**ADDENDUM NO. 2**

**CONTRACT NO. PH4 2010-01  
FOR CONSTRUCTION OF**

**TRLIA PHASE 4  
YUBA RIVER SOUTH LEVEE  
UPPER YUBA LEVEE IMPROVEMENT PROJECT  
PLM 2.2 TO 6.1/STA 102+00 TO 303+59**

**July 30, 2010**

TYPICAL FENCING DETAILS		SHEET
FILENAME	OOC-328.dwg	C-328
SCALE	NONE

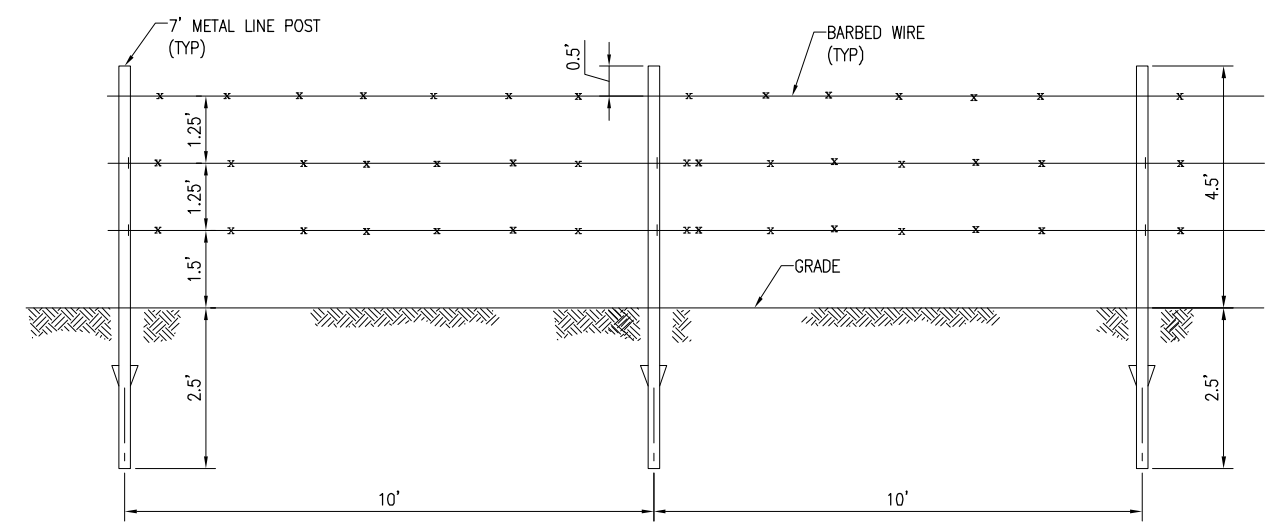
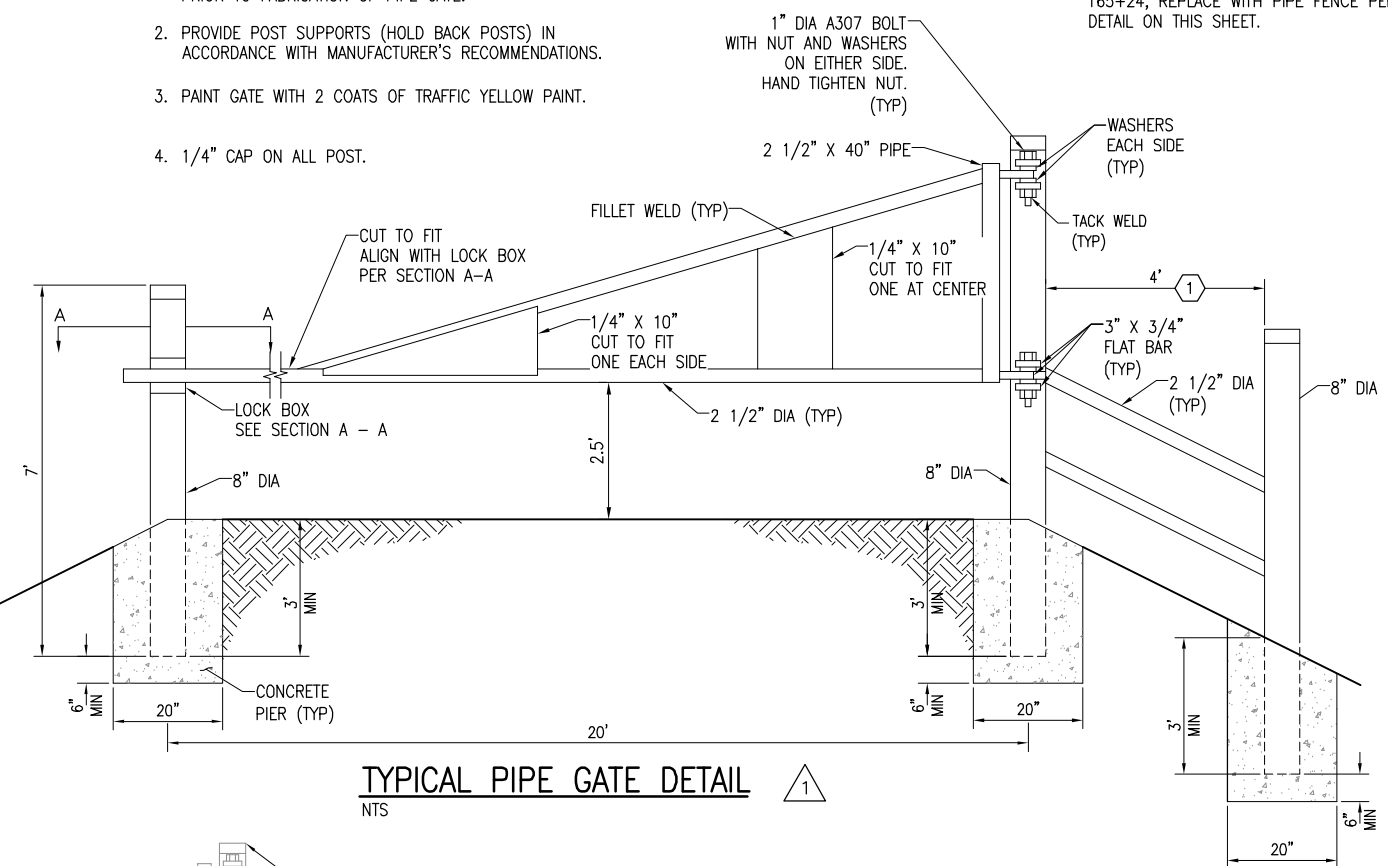
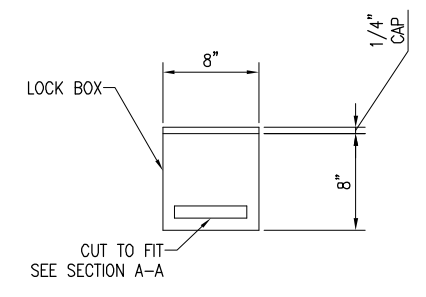
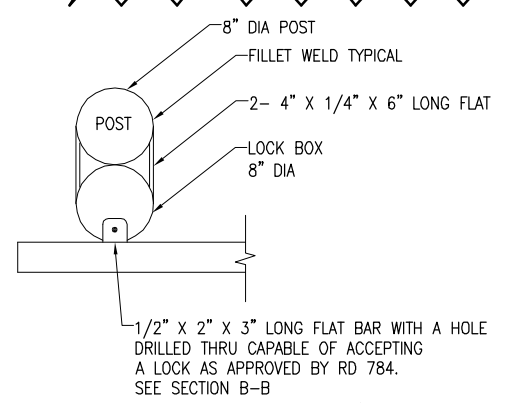
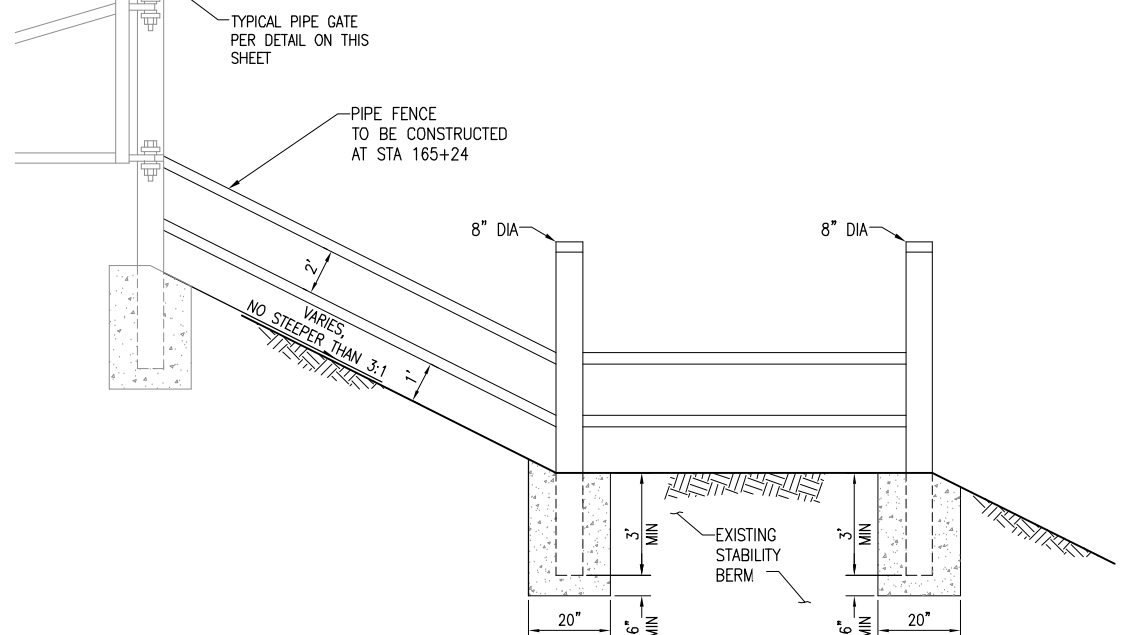
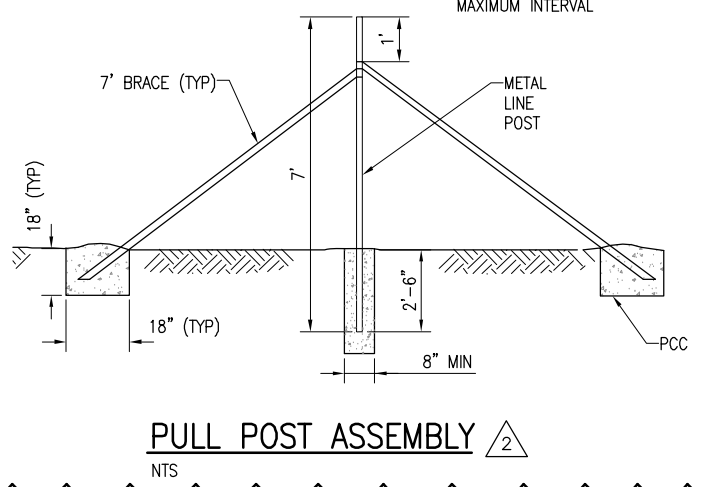
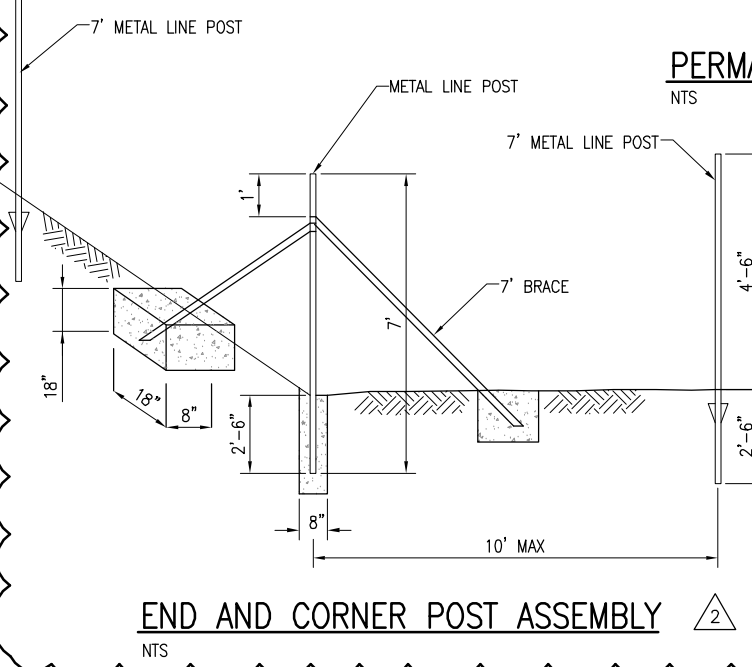
**Replace the following sheets:**

G-000  
C-328
